# Response to Submissions Report

Proposed Data Centre at 57 Station Road,  
Seven Hills (SSD- 33781208)

SEPTEMBER 2022

Figure 1: Plan extract showing area of outdoor open space.  
Source: Studio IZ

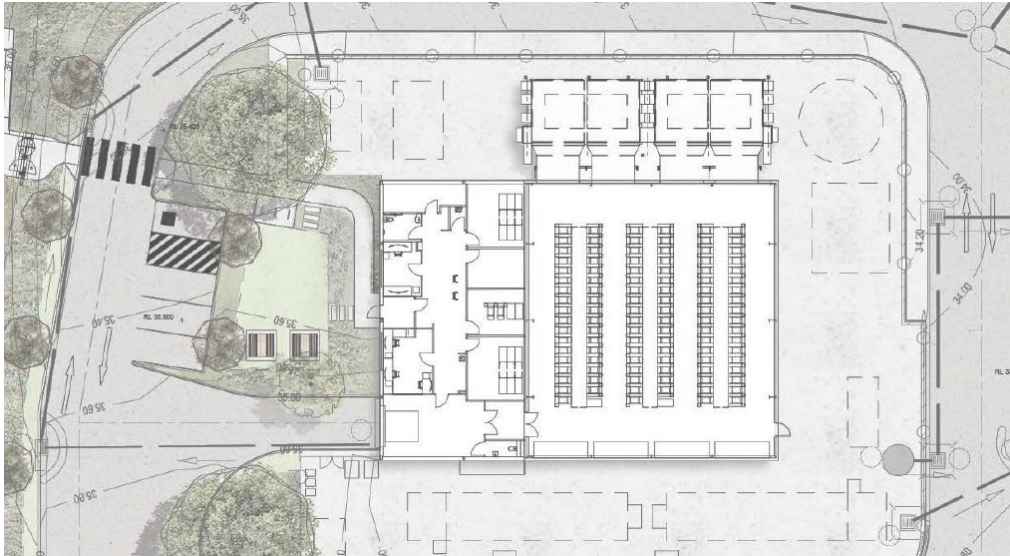
In the Department's RFI, a number of matters were raised in relation to urban design and visual aspects of the proposal. Specifically, this related to clarifications regarding the generator exhaust stacks, the northeast elevation façade treatment, the provision of outdoor recreational areas at the site, and the resolution of the visual impact assessment.

- A high-resolution version of the VIA has been provided as Appendix 12 of the RTS Report.
- As shown on the extract from the approved architectural drawings under DA-21-01058, a generous outdoor area for staff recreation is provided at the front of the SYD09.

Figure 2: Site plan showing inclusion of planting along the perimeter of the carpark  
Source: Studio IZ

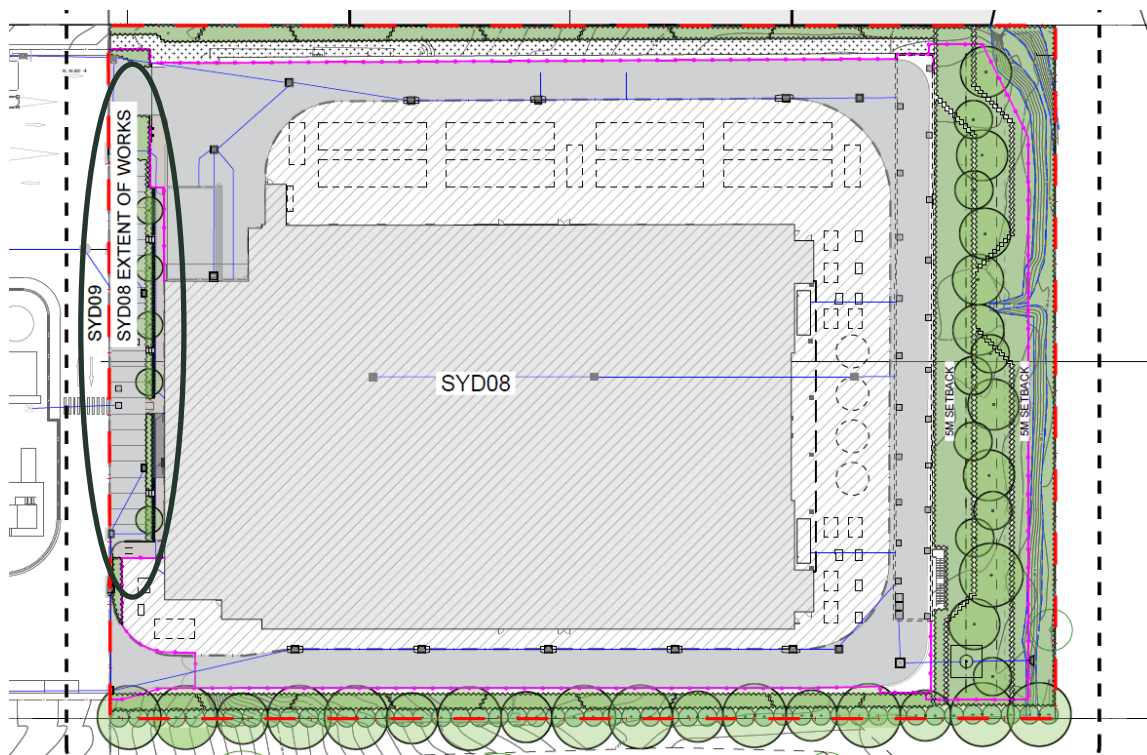
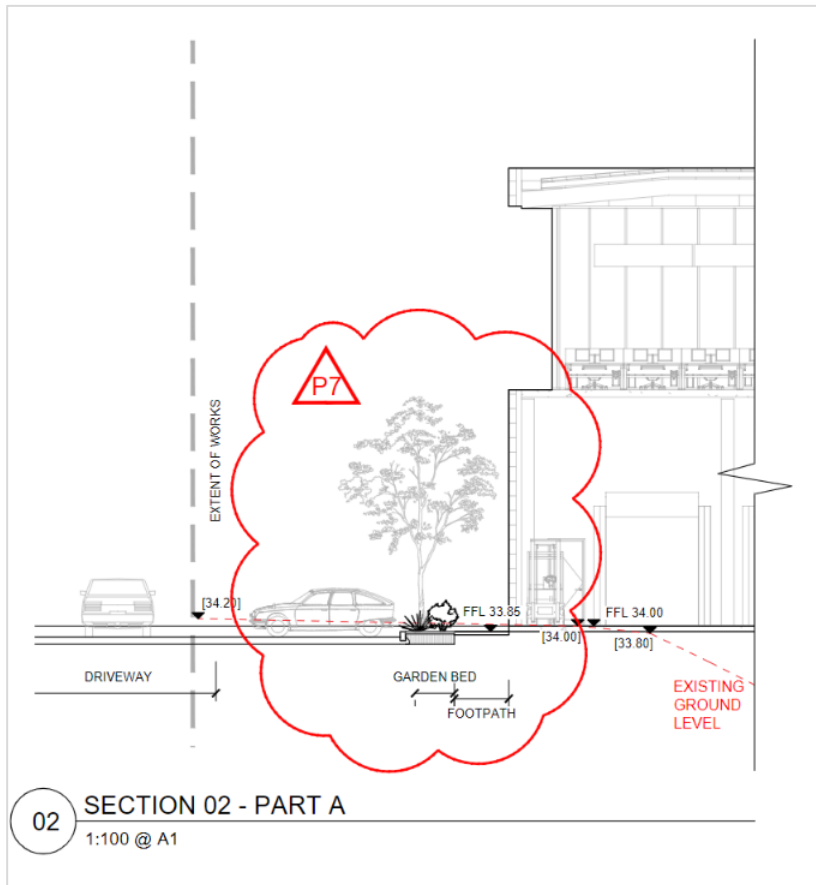
Council requested that a tree be provided for every 10m of carparking within the development to comply with the provisions of Section 4.2 of the Blacktown Development Control Plan (BDCP) 2015.

In response, the landscaping design has been amended to provide for five (5) new trees in the car parking area which is approximately 60m in length. Whilst it is acknowledged that strict compliance with the BDCP 2015 control is still not achieved, the solution is considered acceptable as:

- With the introduction of new planting, the departure from the DCP control will ultimately be minor, with 5 trees provided when 6 trees are otherwise required. Furthermore, it is noted that DCPs technically do not apply to SSDAs.

Figure 4: Concept plan demonstrating potential for additional parking to be provided  
Source: DEM Architects

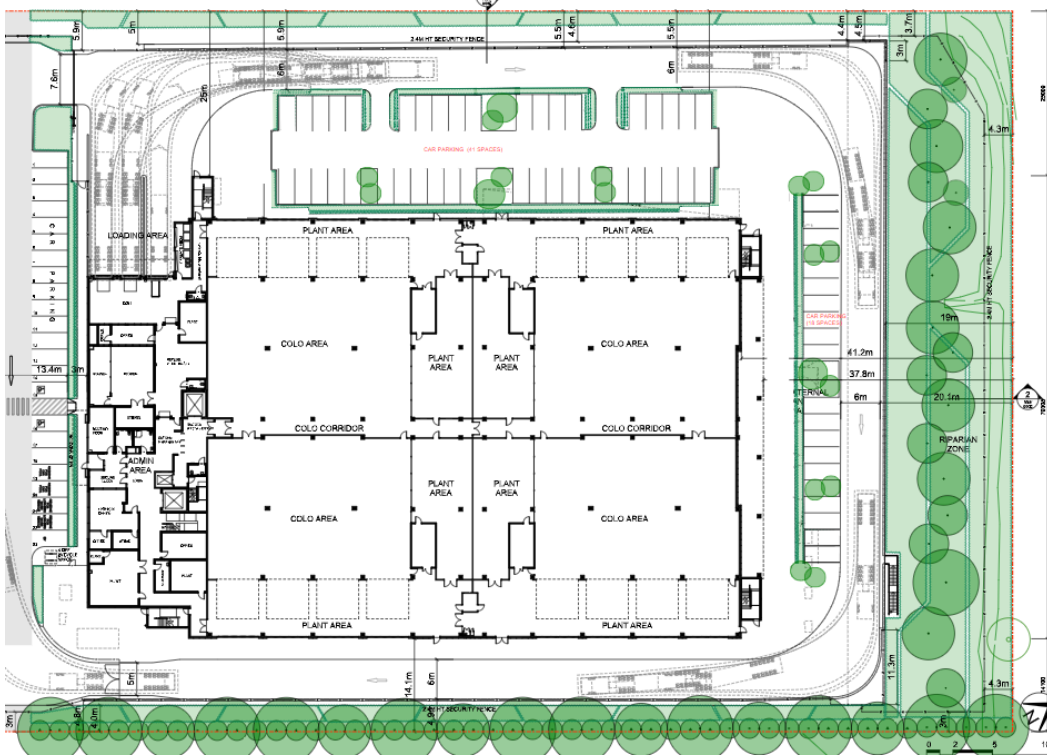
Council's submission raises concern with the proposed provision of an additional 15 car parking spaces, resulting in the whole site being serviced by a total of 31 car parking spaces. Council requested that the development comply with the car parking rates for industrial and office developments under BDCP 2015, requiring the provision of a total of 85 car parking spaces overall.

Council's submission acknowledges that the predicted staff numbers for the data centre would not demand this number of spaces, however they are of the opinion that there is the potential for the building to change use in the future.

Notwithstanding the above, the applicant agreed with Council following the receipt of its submission that an acceptable outcome would be to demonstrate the site's potential to provide for additional parking should a future change of use occur. As such, DEM have prepared a concept plan (Appendix 5) which identifies that the rear portion of the site could provide 86 car parking spaces by utilising areas currently dedicated to plant equipment.
